**RE: Review of Form 28 Centralized E&P Waste Management Facility Permit  
Facility ID #441234, De Beque Water Station  
Black Hills Exploration and Production  
SESE Section 29, T8S, R97W, 6<sup>th</sup> PM, Mesa County, Colorado**

In response to your comment letter dated May 4, 2015, we have prepared additional information for the above-referenced project to address COGCC's comments and concerns. All comments that had a COGCC Comment of "None" were not addressed in our responses. The following information reiterates your comments and our specific responses to each comment as follows:

**PUMP STATION BUILDING LAYOUT**

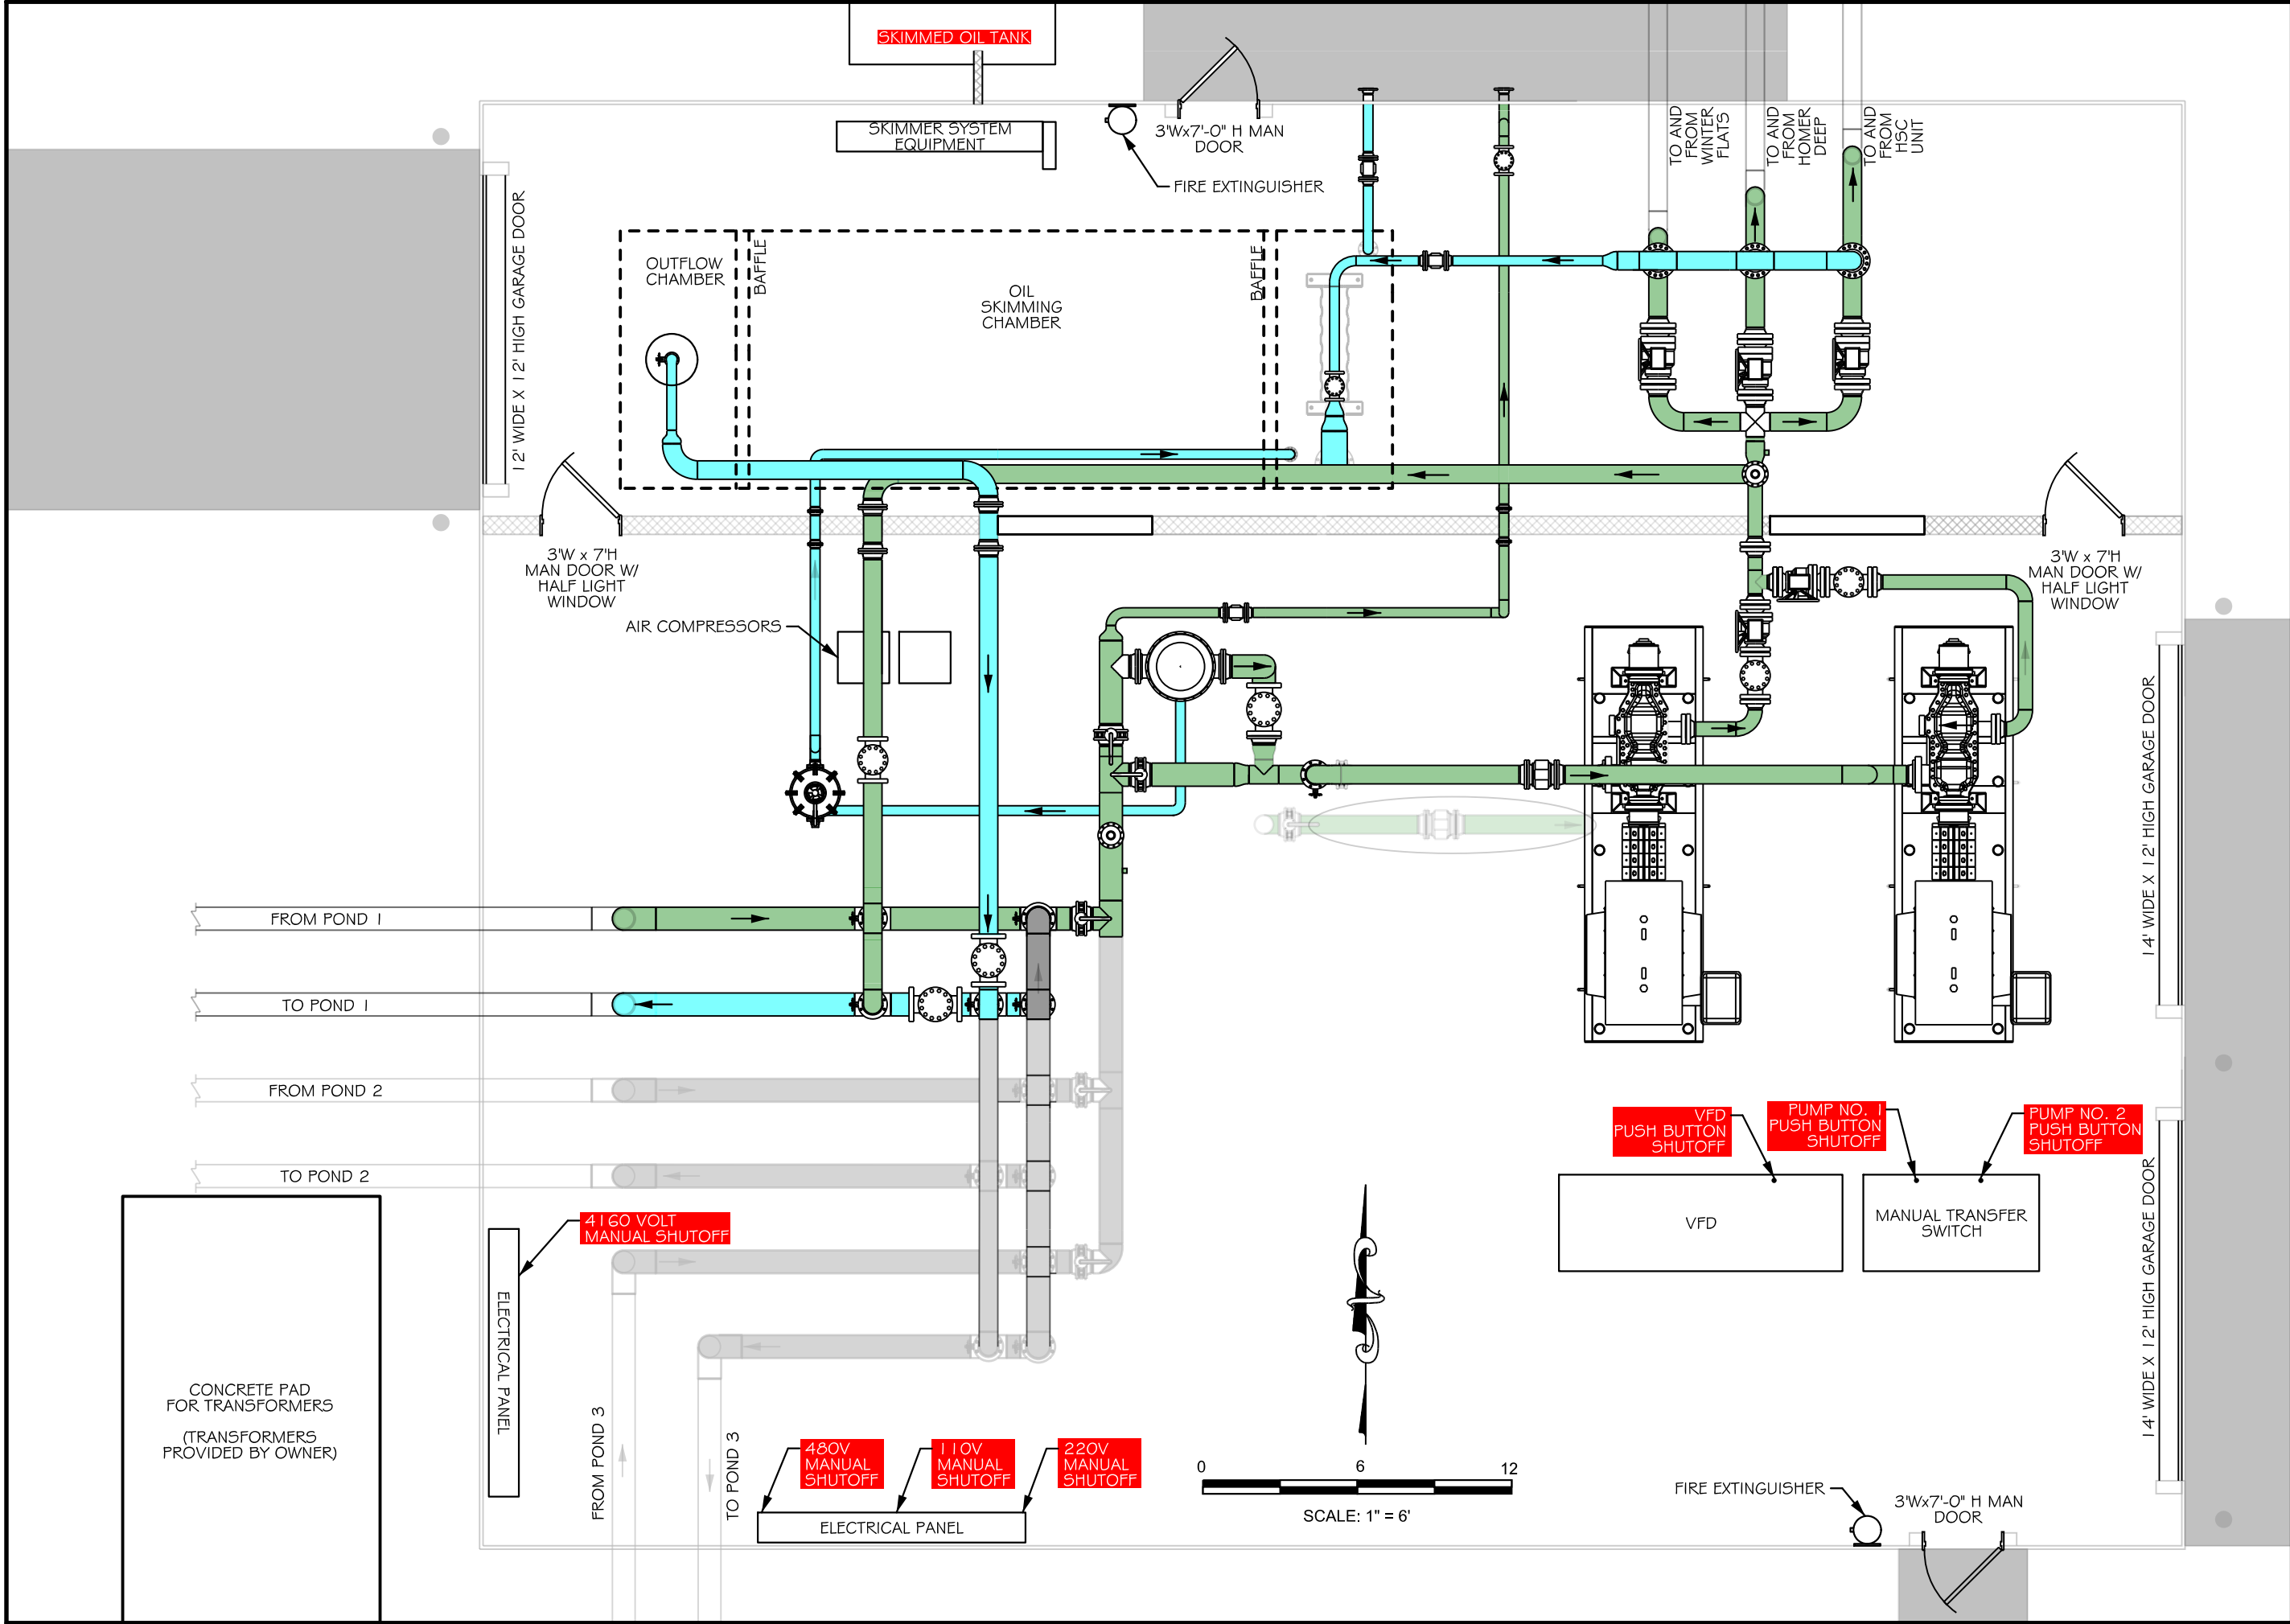
Is there any emergency response control valves associated with this Facility?

**Response:** *There are a number of valves located within the pump station building that give the operator the flexibility to shut down or isolate incoming/outgoing flows. An exhibit was created for the De Beque Fire Station Department showing the location of these valve shut offs. This exhibit has been included as Exhibit C.*

**DE BEQUE WATER STATION  
SECTION 29, T8S, R97W 6TH P.M.  
ONE MILE WATER WELL MAP**

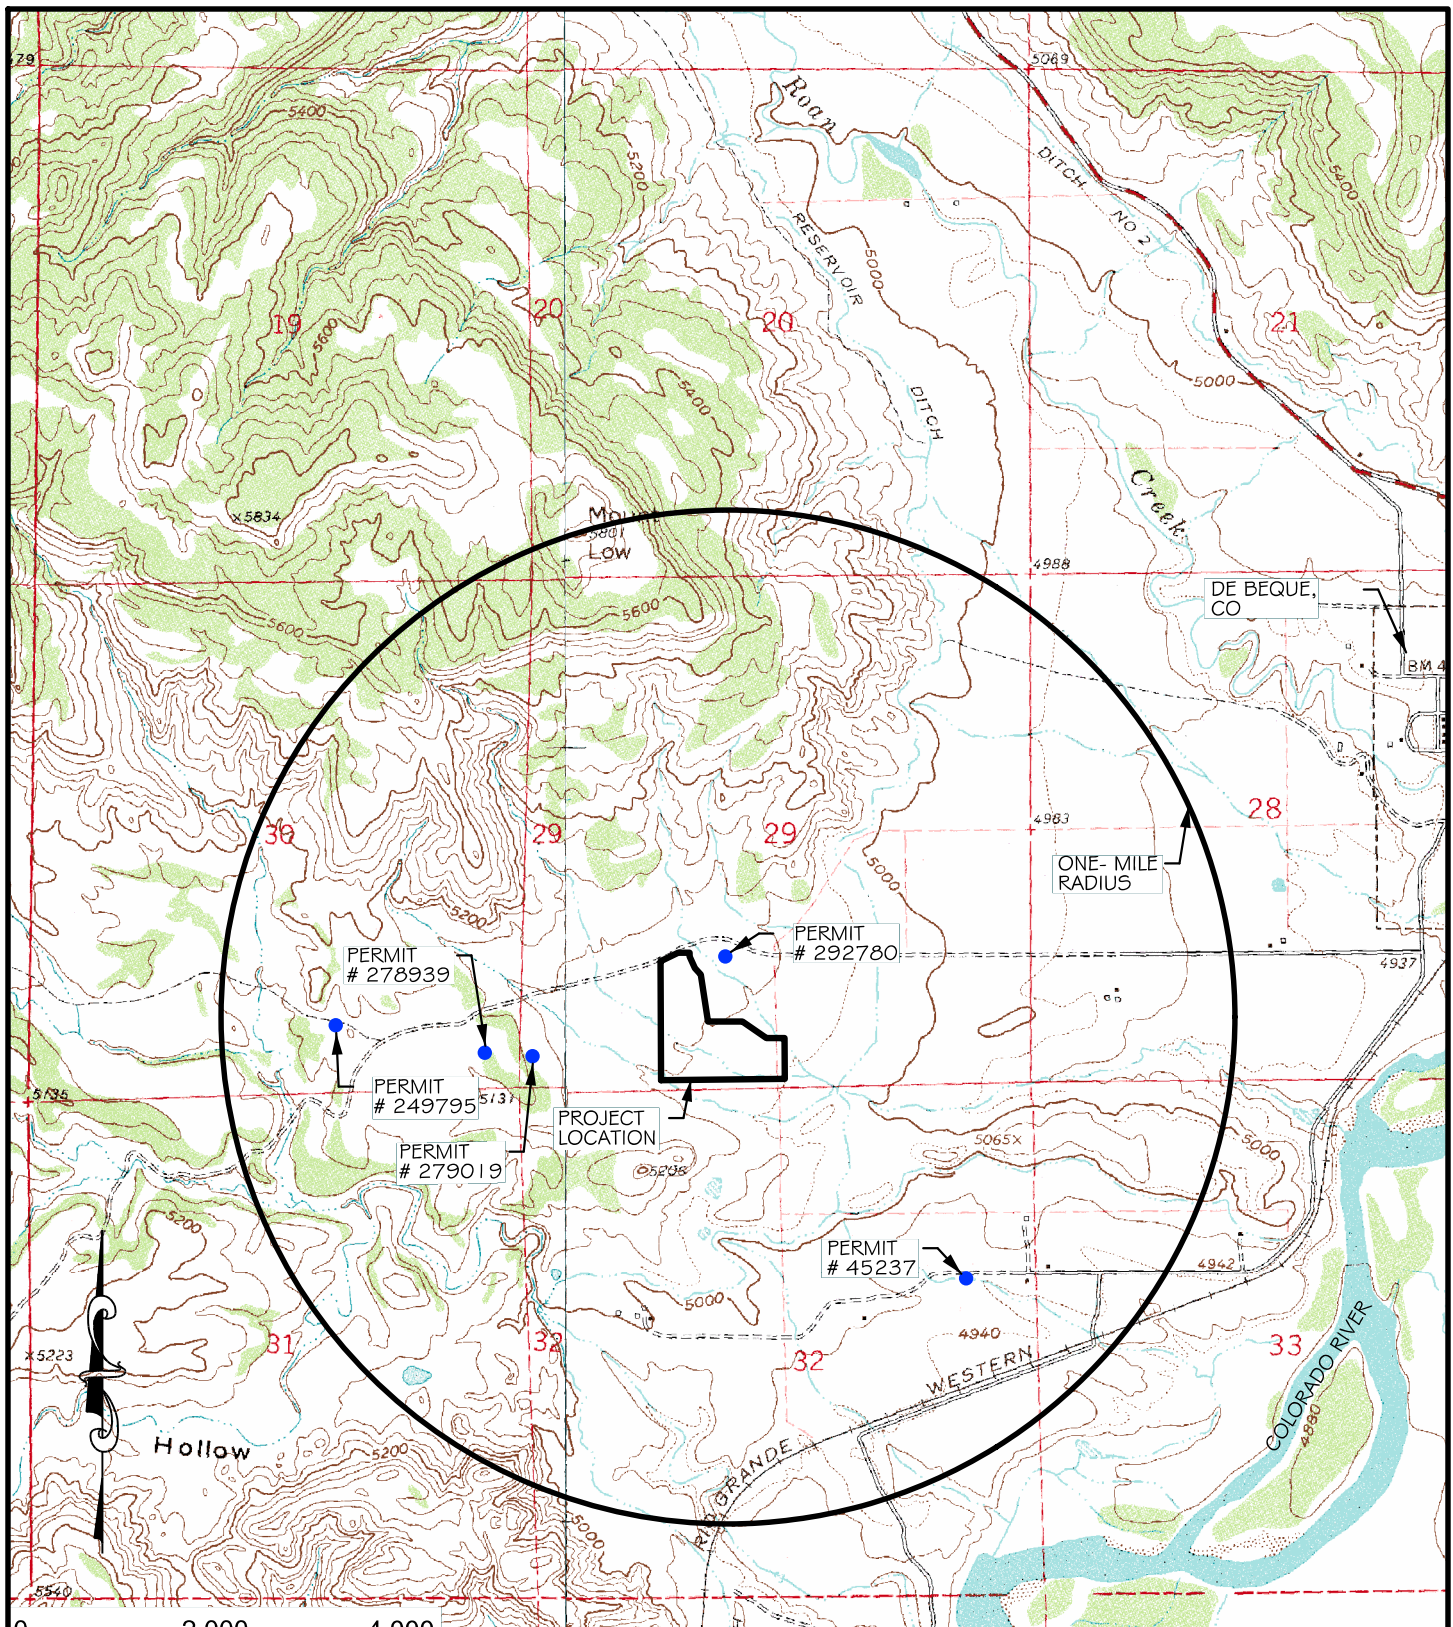
Several water wells are located within a one-mile radius and at least two water wells within a quarter of a mile and one-half mile. These wells indicate the depth to static ground water up to 27 feet below ground surface (bgs). Please provide an explanation.

- ***The depth to groundwater at the Facility is greater than 100 feet.***
- ***The well logs that were shown in Appendix B of the Form 28 submittal are summarized and shown on an updated Exhibit 7. Wells with permit No. 45237 and No. 292780 show a static water level of 27 feet and 36 feet, respectively. The total well depth for permit No. 45237 is 304 feet and the perforated casing depth is 220 feet to 270 feet (the depth at which the water is entering the well). The total well depth for permit No. 292780 is 430 feet and the perforated casing depth is 370 feet to 410 feet. These results show that these wells are drawing water from a confined aquifer and the artesian pressure of the aquifer causes the static water level to rise to the potentiometric surface.***
